To: Howard Resnik, PE
From: Pat O’Mahony, Associate Planner; 910-341-0189
CC: File;
Date: 12/1/2021
Re: Switchyard TRC Rev. 2

Project Name: Switchyard

Formal TRC #2 Date: **11.30.2021**

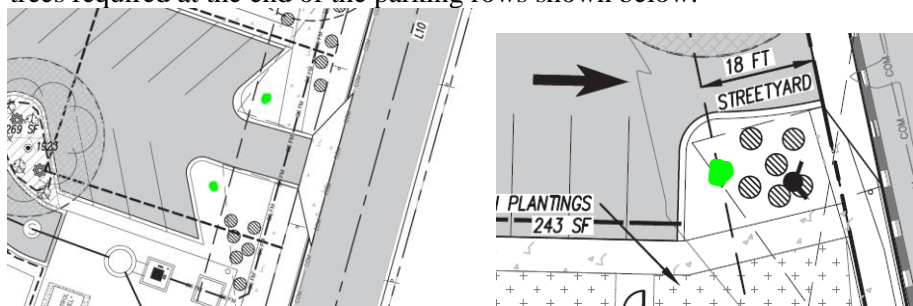
- Canopy trees required at the end of the parking rows shown below.

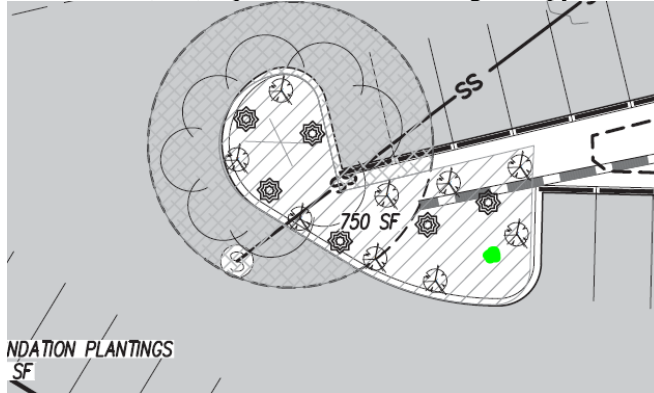
- Sec. 18-457g.: A minimum of fifteen (15) trees at least two (2) inches DBH shall be retained or planted on the parcel for each acre or proportionate area disturbed by development. Show compliance in landscape calculations.
- All larger planting islands will have additional trees in increments of one (1) tree for each additional two hundred (200) square feet if installing small shade trees or one (1) tree for every four hundred (400) square feet if installing canopy trees. Additional tree needed.
